DEPARTMENT OF HAWAIIAN HOME LANDS
STATE OF HAWAII

ADDENDUM NO. 1 TO
PROPOSAL, SPECIFICATIONS, CONTRACT AND BOND FOR
IFB NO.: IFB-12-HHL-001

KAKAINA SUBDIVISION, WAIMANALO

ADDENDUM NO. 1
TO PROPOSAL, SPECIFICATIONS, CONTRACT AND BOND FOR
KAKAINA SUBDIVISION, WAIMANALO, OAHU, HAWAII
TAX MAP KEY: 4-1-08: 10, 81, & 91
IFB-12-HHL-001

2/24/2012	REVISE NOTES	A&A	
	REVISION DATE	DESCRIPTION	MADE BY
DEPARTMENT OF HAWAIIAN HOME LANDS			
KAKAINA SUBDIVISION			
TAX MAP KEY: 4-1-08: 10, 81, 91 & 92 WAIMANALO, KOOLAUPOKO, OAHU, HAWAII			
GENERAL NOTES			
AKINAKA & ASSOCIATES, LTD. CONSULTING ENGINEERS			
FILE	POCKET	FOLDER	NO.

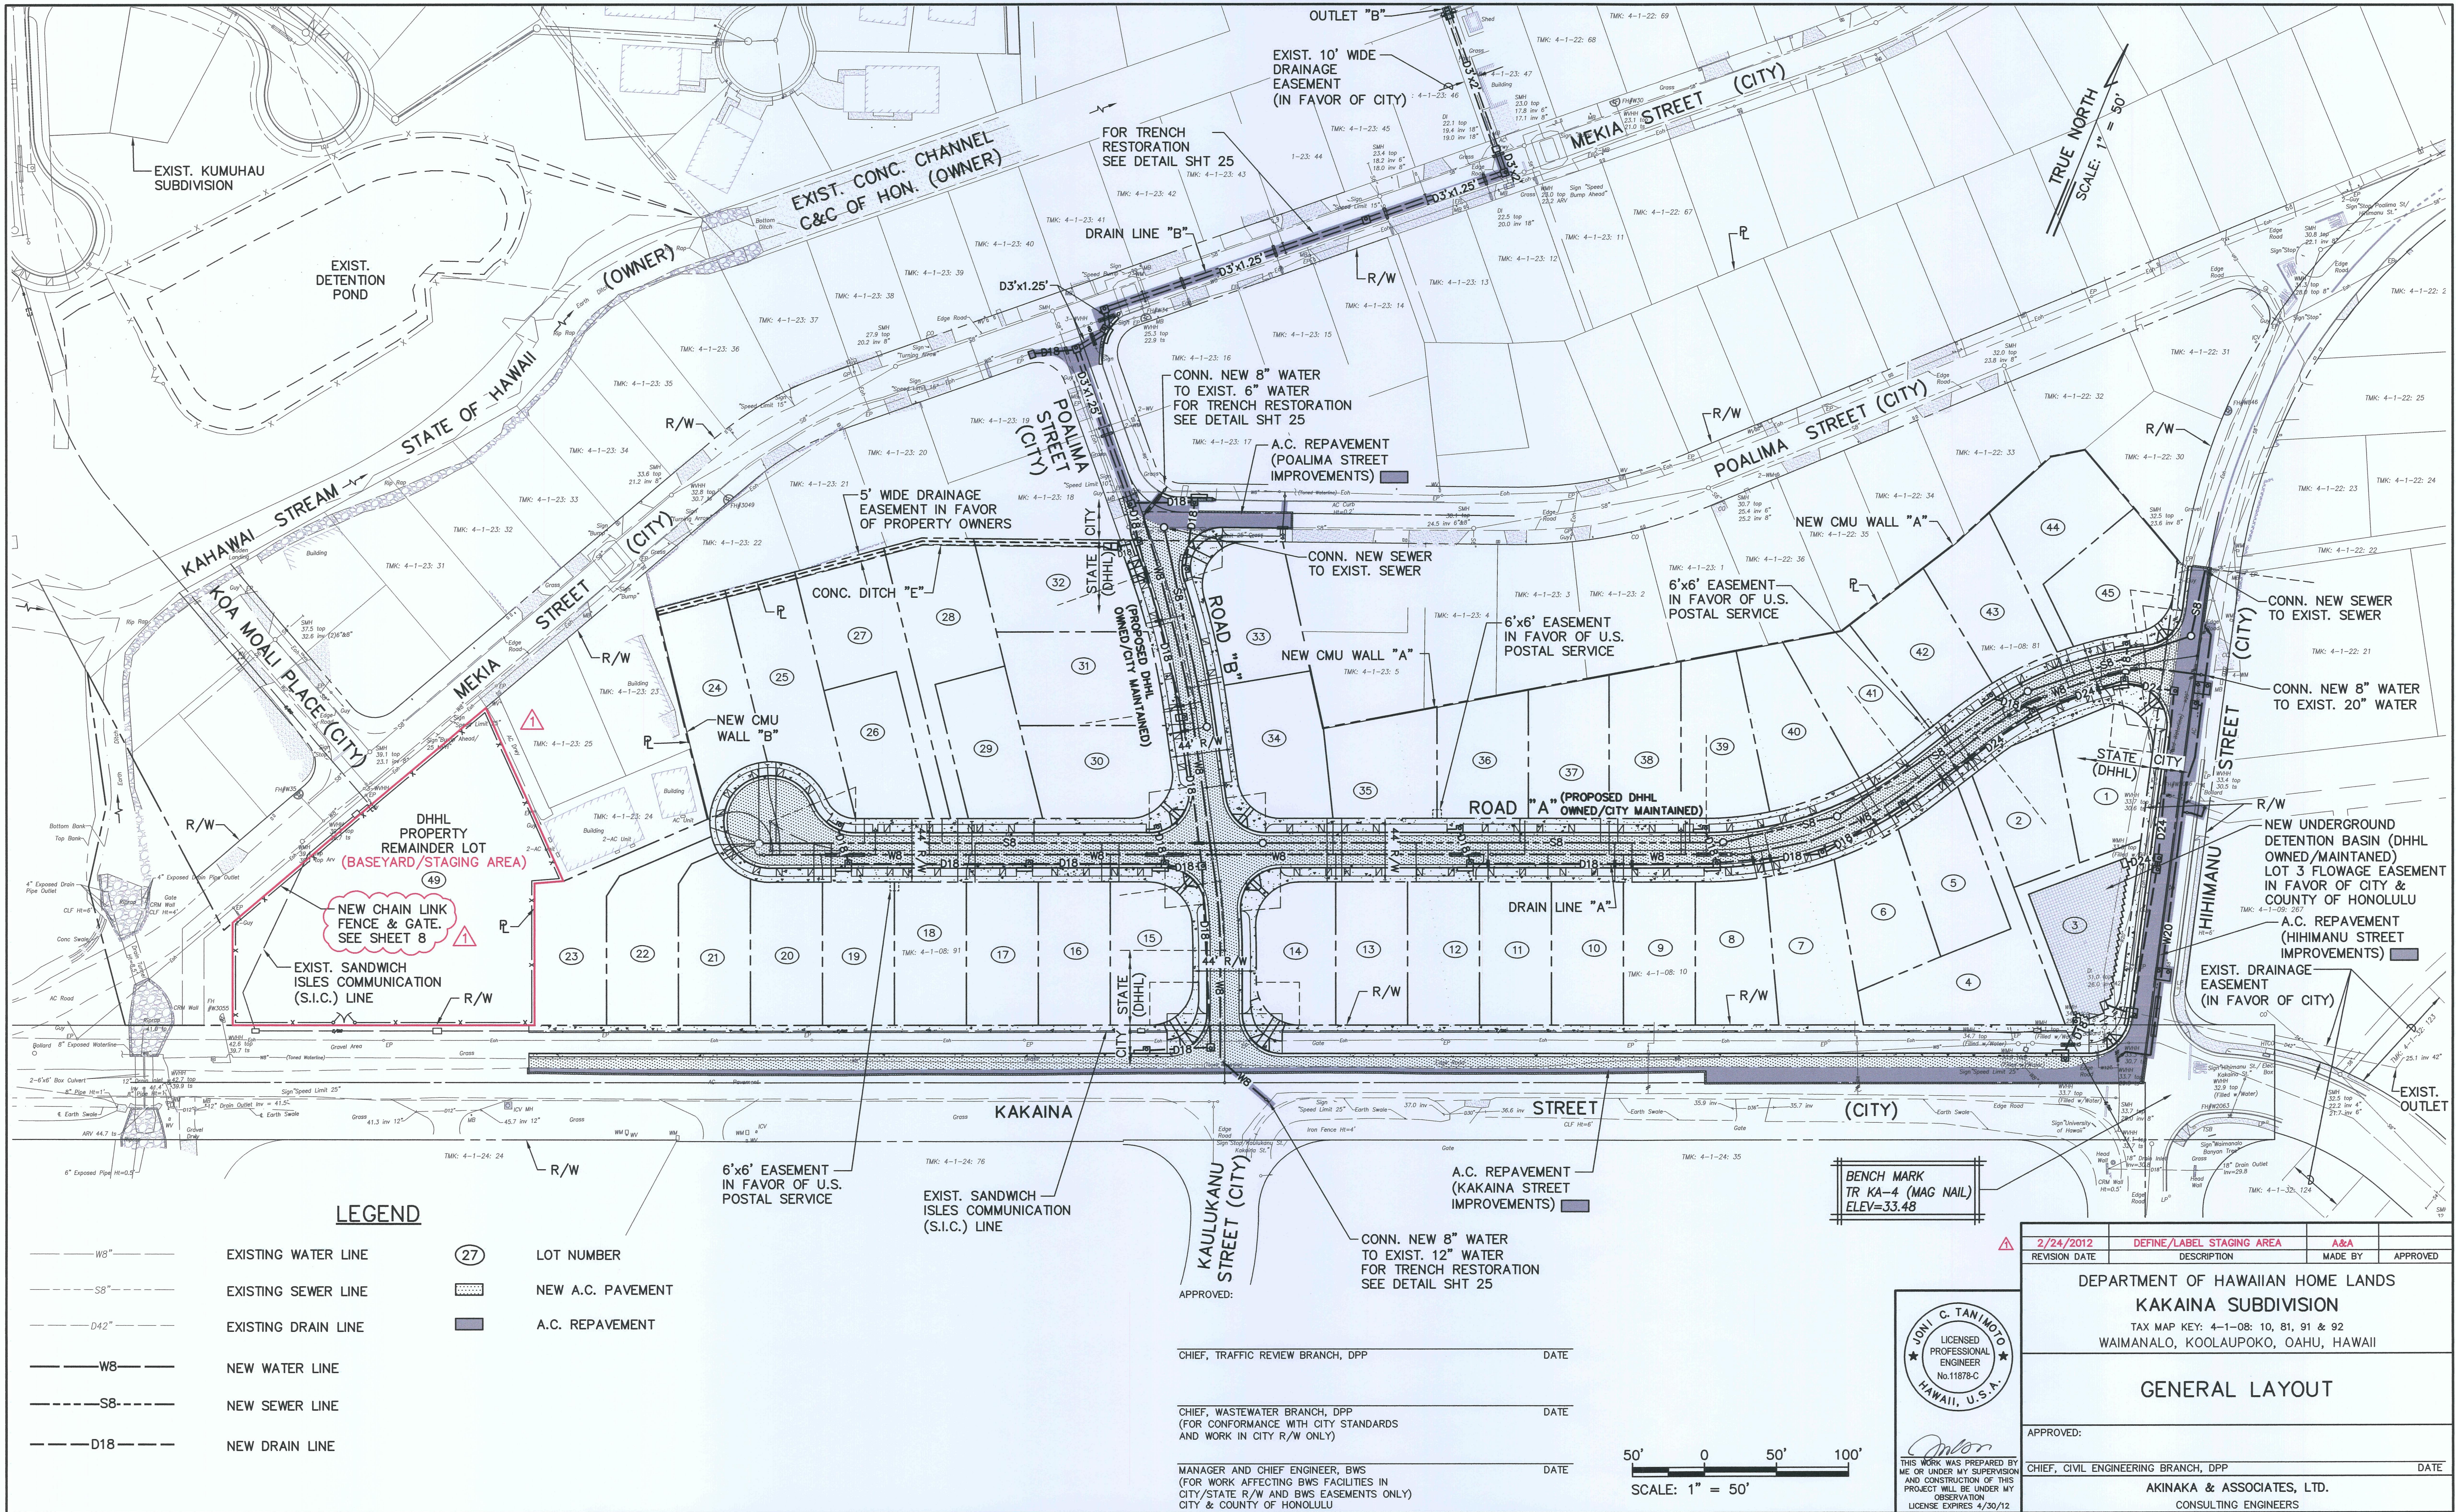
Technical specs state VCP for the sewer line, plans show PVC. What is the specification for the PVC pipe on the sewer line?

- Sewer line shall be PVC. The technical specification has been revised to reflect PVC material.

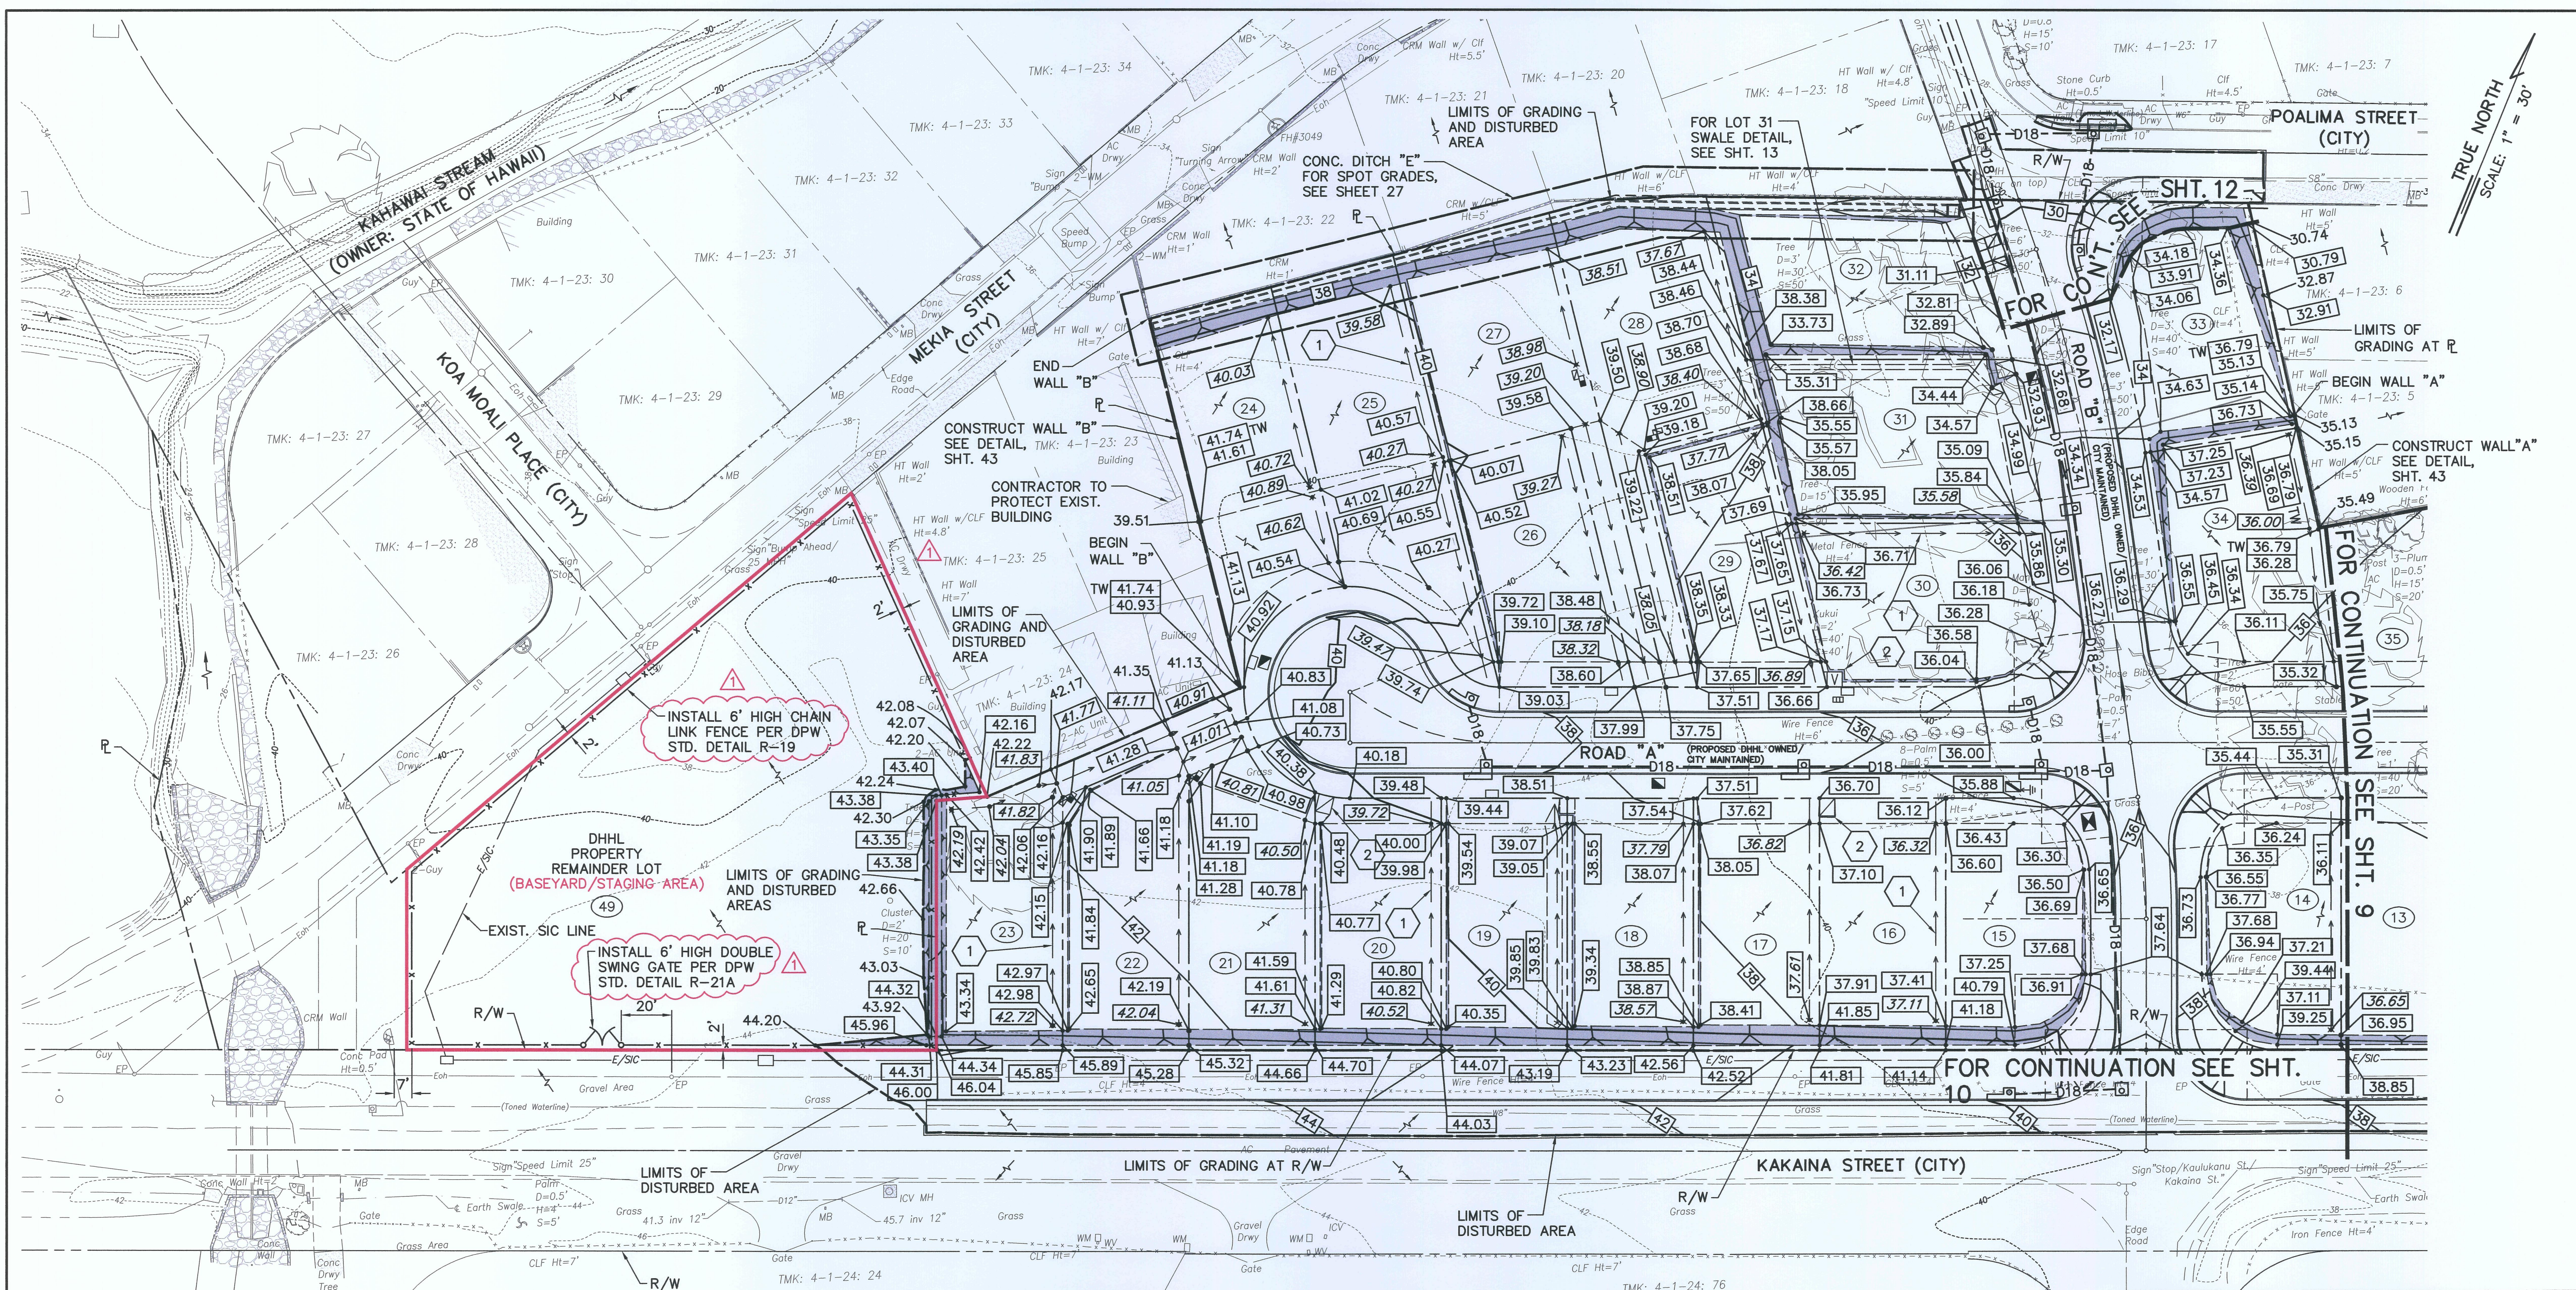
- Plans have been revised to indicate the staging area
- A separate pay item has been added for the grassing of the staging area after demobilization
- Contractor to install chain link fence (CLF) with double swing gate (permanent) around the site as indicated in the addendum set plans. Pay items added for the CLF and gate.
